UNITED STATES ENVIRONMENTAL PROTECTION AGENCY
WASHINGTON, D.C. 20460

This letter provides the results of the U.S. Environmental Protection Agency's (EPA) baseline inspection of the remote-handled (RH) transuranic (TRU) waste characterization program implemented by the Central Characterization Project (CCP) at the Los Alamos National Laboratory (LANL) (Inspection Number EPA-LANL-RH-CCP-05.07-08).

DOCKET NO: A-98-49, II-A4-96

February 2008

Figure 2. Removable Lid RH Canister with three 55-Gallon Drum Payload

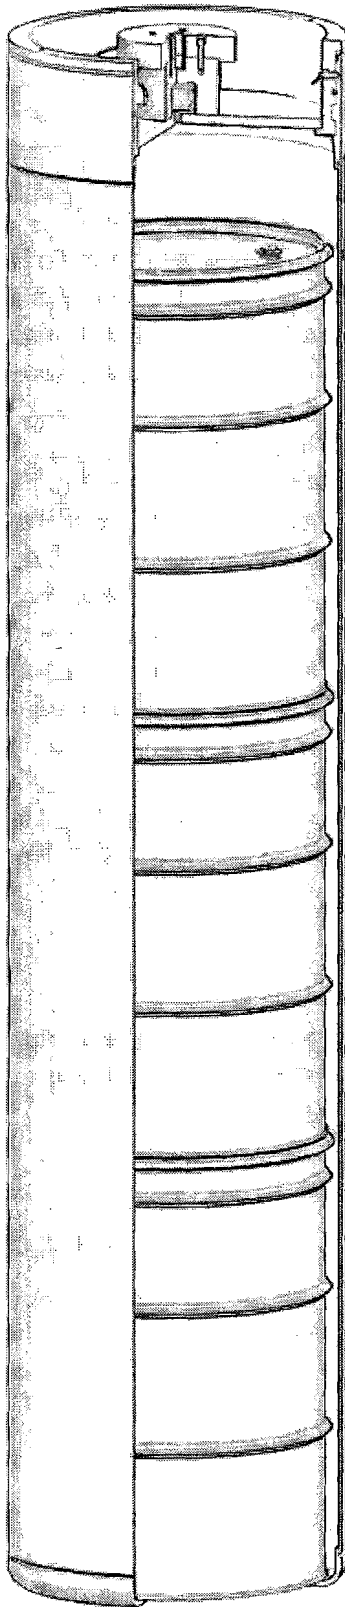
Initial Comment No. 4c: The WCIR states that there are “up to 12 welded-shut cans” (page 8), or “to a maximum of 12 cans per drum” (page 10), or “up to 12 cans” (page 42), which leaves the impression that the 55-gallon drums contained differing numbers of steel cans. However, according to the AKSR, each of 30 drums had exactly 12 steel cans and one drum had 4 steel cans. The WCIR report language should be changed to correctly state the actual configuration.

EPA Response to Initial Comment 4c: *EPA agrees with the Commenter and the sections of the text that were cited in the comment have been revised as follows:*

Page 8: Figure 2 presents the assembly of the RH canister containing up to three drums, each of which contains 12 welded-shut cans.
